10 Minshull Street and 11 Bloom Street

TANKING DETAILS PROPOSALS - WALLS

PLANNING CONDITIONS RELEASE 11(e)

Planning Permission 119374/FO/2018 – BOTH BUILDINGS

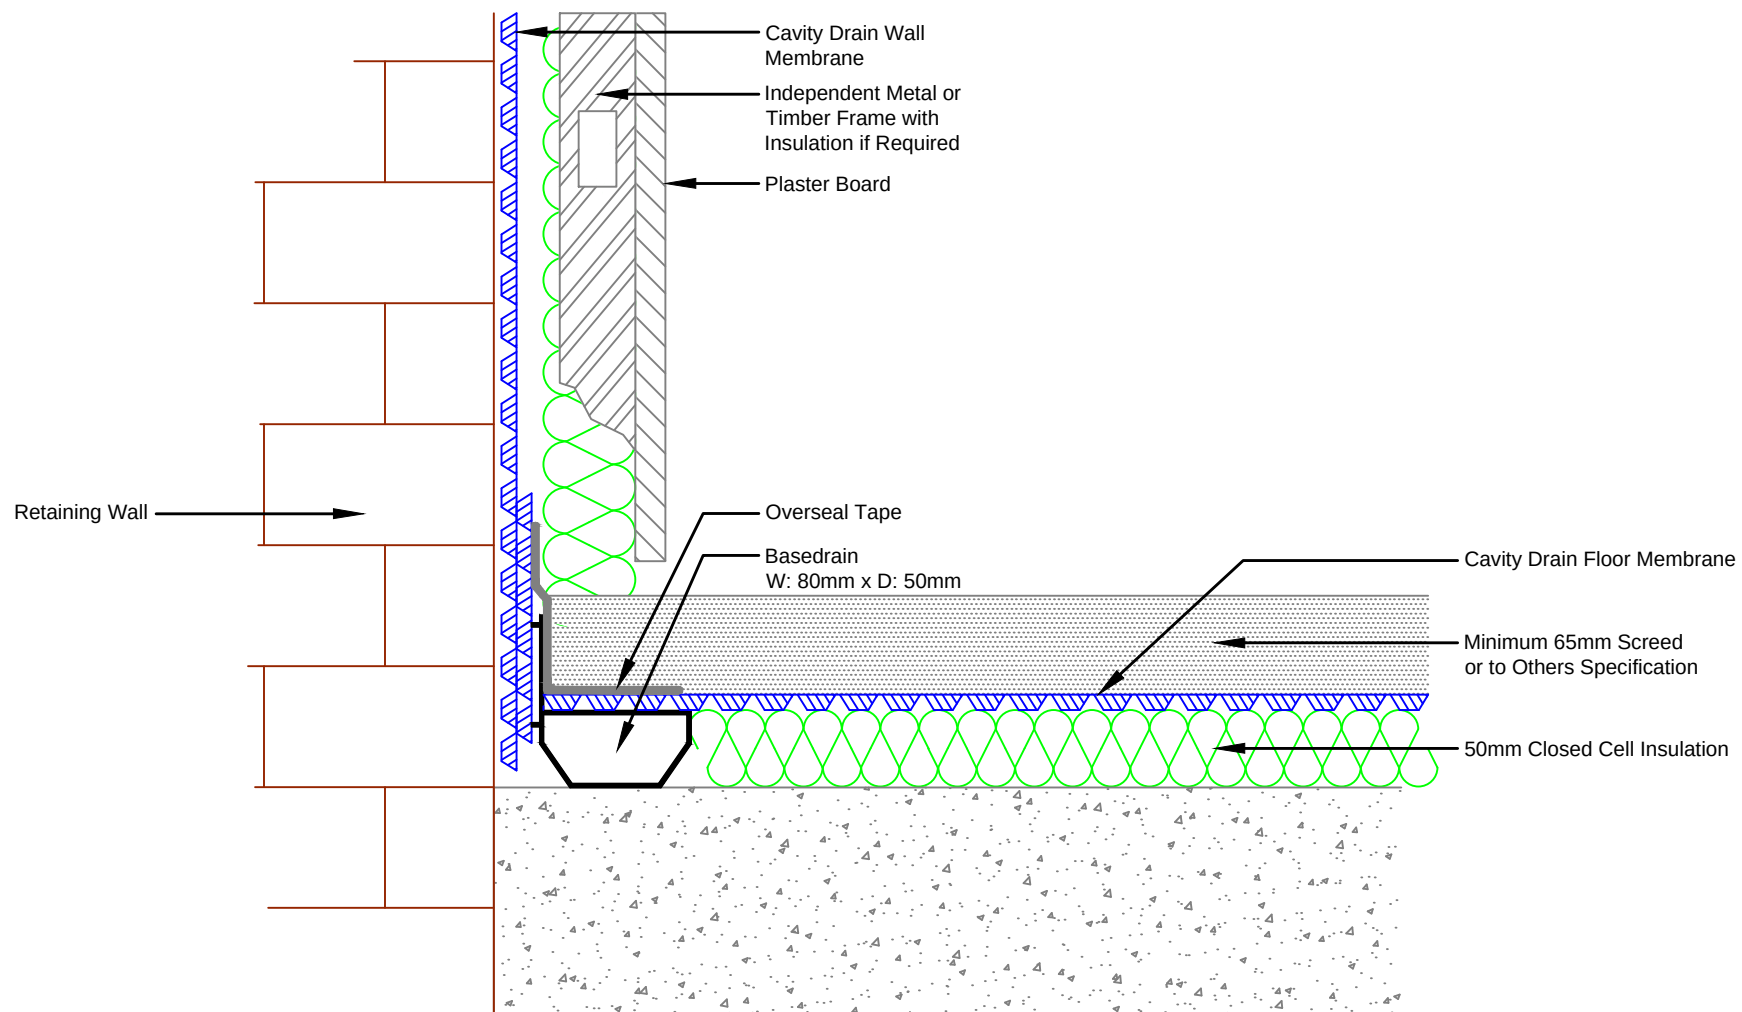
My understanding is this suggestion is one put forward by the planners, as they wish to leave an area of original brickwork exposed for future generation to view?

Whilst I have no strong objection with this suggestion, I advise you emphasize to the planners that the exposed section of masonry will, especially during the early stages of drying, be prone to damp patching and salting that may be unsightly. This may cause the end user, home owners or tenants some annoyance as there decor may become spoilt and require remedial work on a fairly regular basis.

As denoted above, the stone / column detail works very well.

The window reveal details seem to work well, but I would like to better review such on site.

1 | TYPICAL ELEVATION - TANKING FIXINGS
1:10

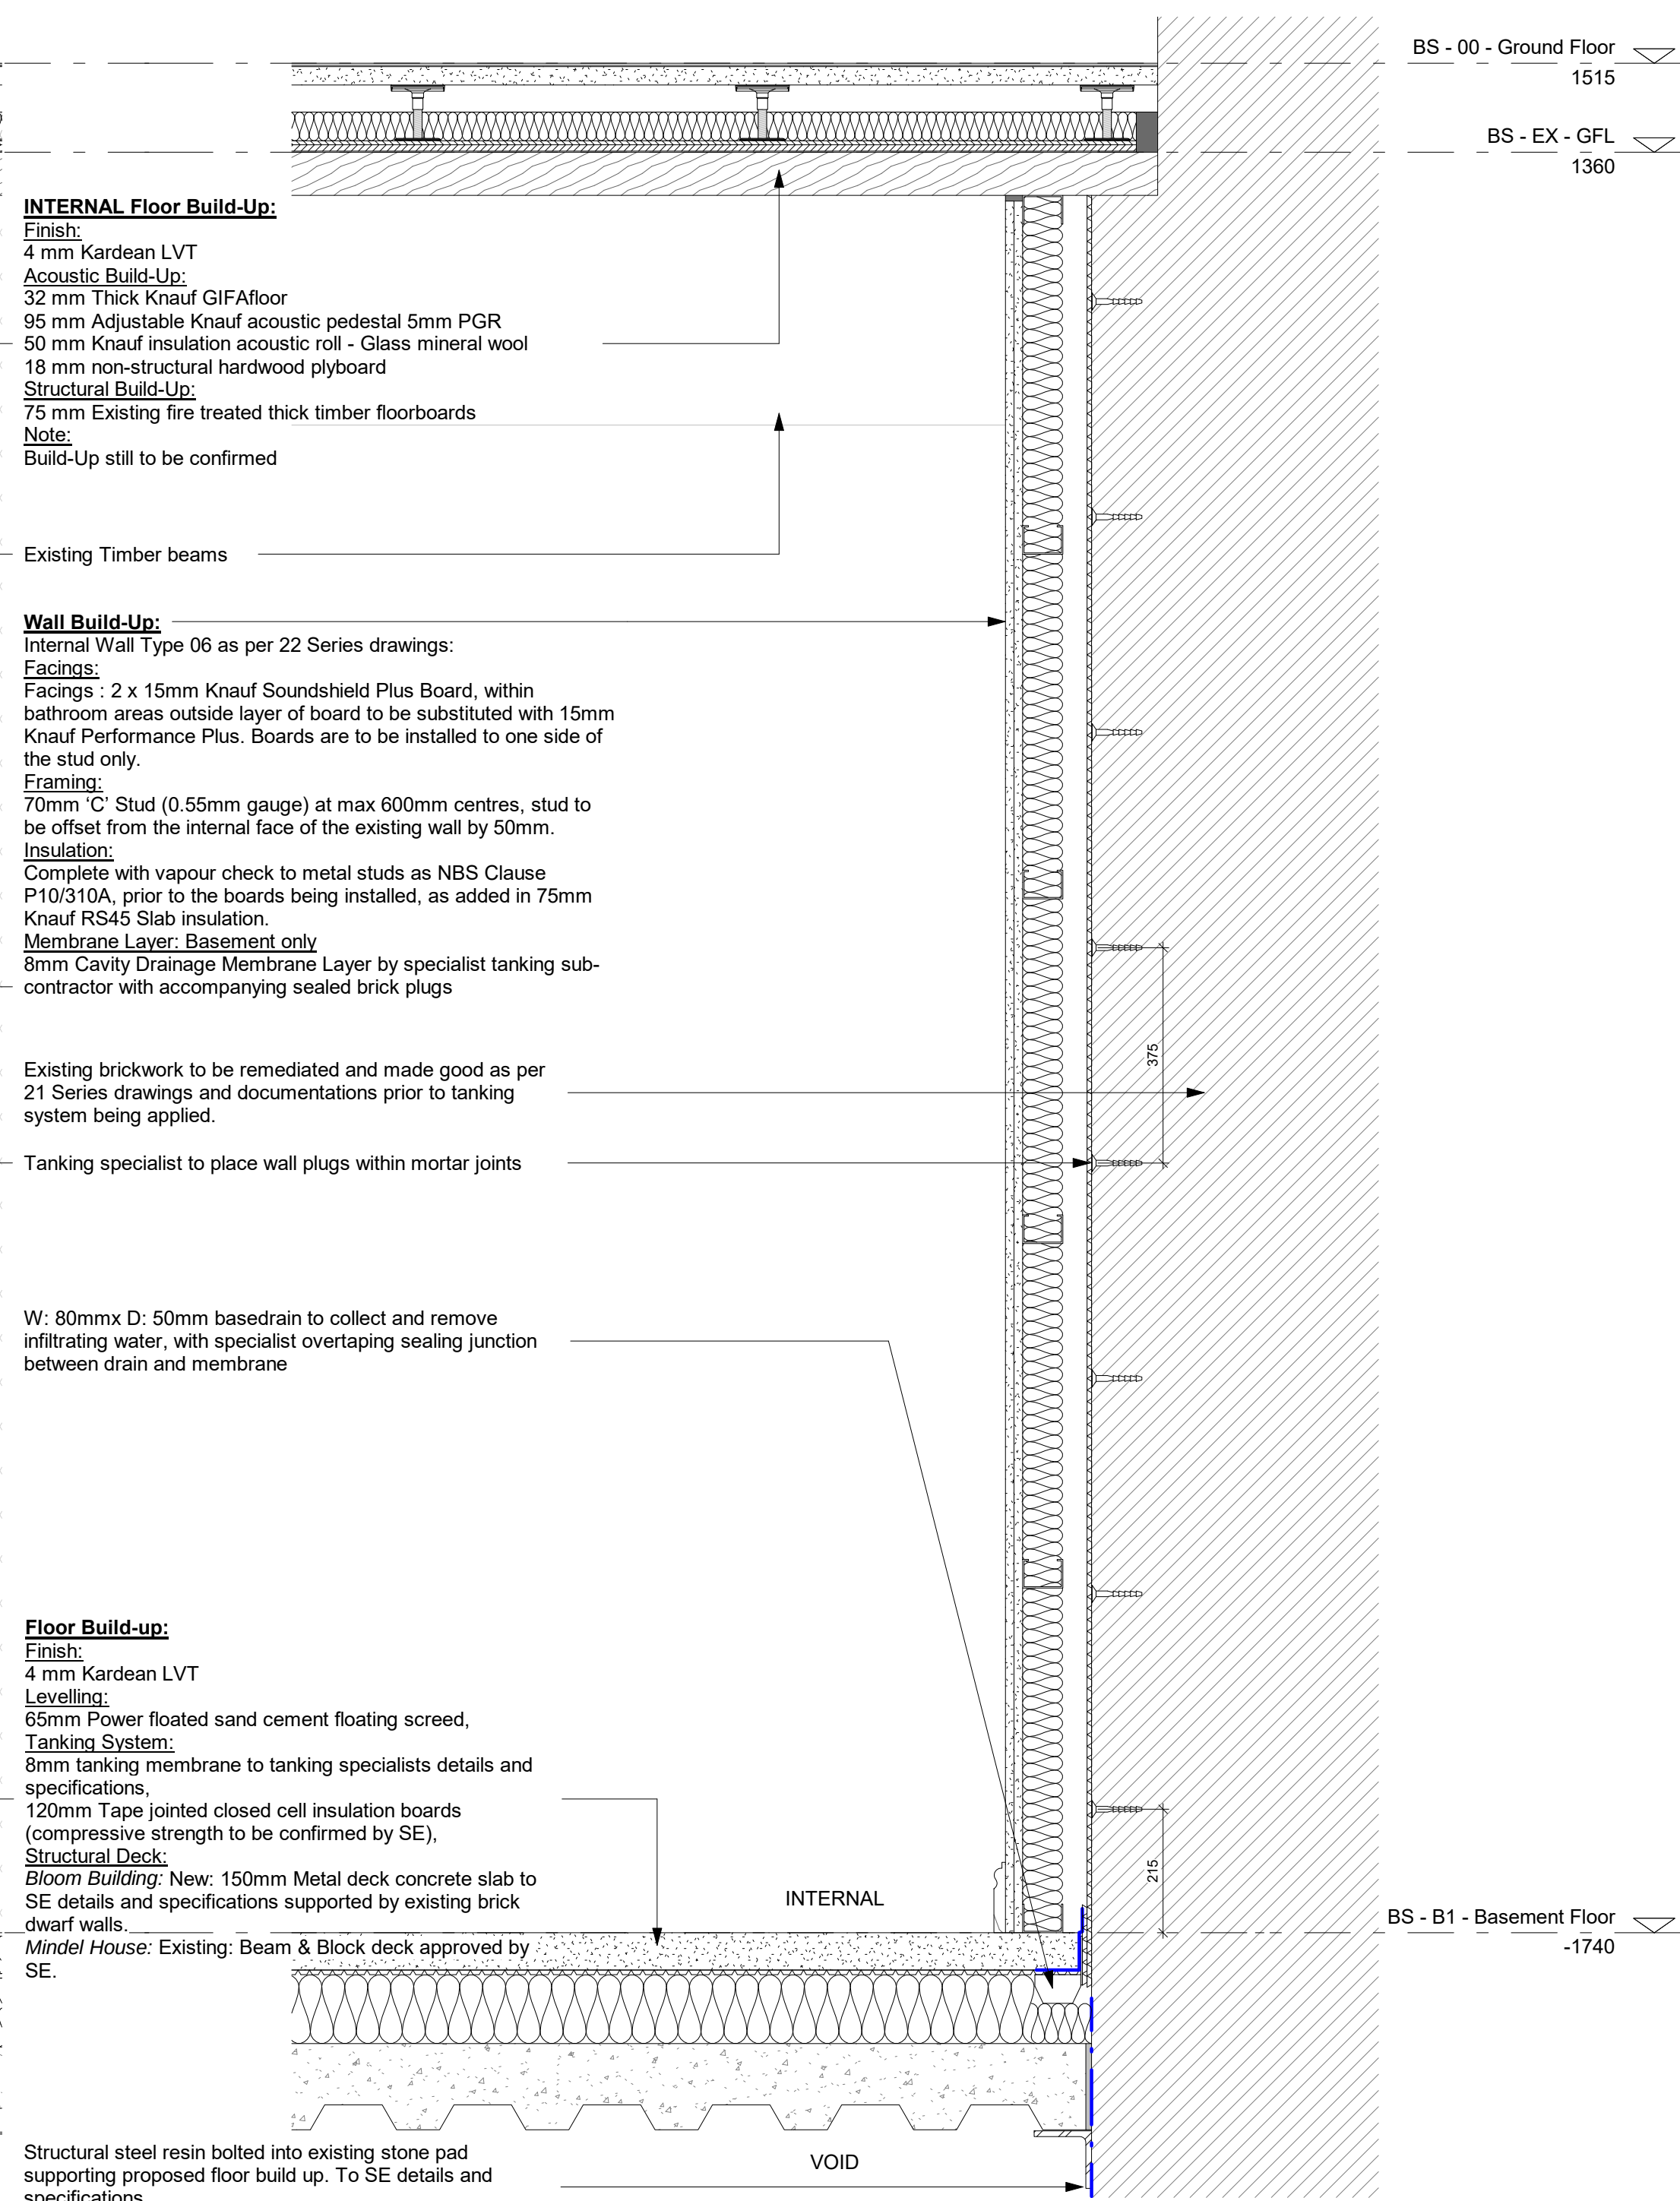
Concerns were raised (**Appendix D**) with regards to the fixings necessary for the installation of the tanking system and the ability for the installation to be reversible. After a site inspection by the Protectahome, a proposal for the number and placement of fixings was established and a typical drawing produced by MDB in conjunction by the specialist, which is presented within the report (**Appendix E**), along with the images shown in of heritage case studies Protectahome have worked on (**Appendix C**). The proposal has sought to include the minimum amount of fixings necessary to facilitate the effective installation of the system whilst taking into account the nature of the heritage of the building and the potential intervention to the internal perimeter walls. Further to this it serves the contractor to reduce the fixings as much as possible for obvious cost savings in materials and time. Secondly the fixings are proposed in a manner that minimally effects the bricks, seeking to introduce the wall plugs in mortar joints, this again serves the purposes of the building in minimal intervention to the building and increases the ease of installation for the contractor on site.

- (b) The submitted information advises that the number of fixings to the existing walls would be minimised and into mortar joints which is welcomed, but a typical internal elevation detail should be submitted to show the number of fixings required in any given area of the installation. The submitted information also appears to suggest ((2.2(c), Para 40) that increased intervention can be employed in certain locations such as doors and windows seemingly to 'over-engineer' the design in what are perceived as possible more vulnerable locations. This should be avoided or better explained and detailed in drawn form.
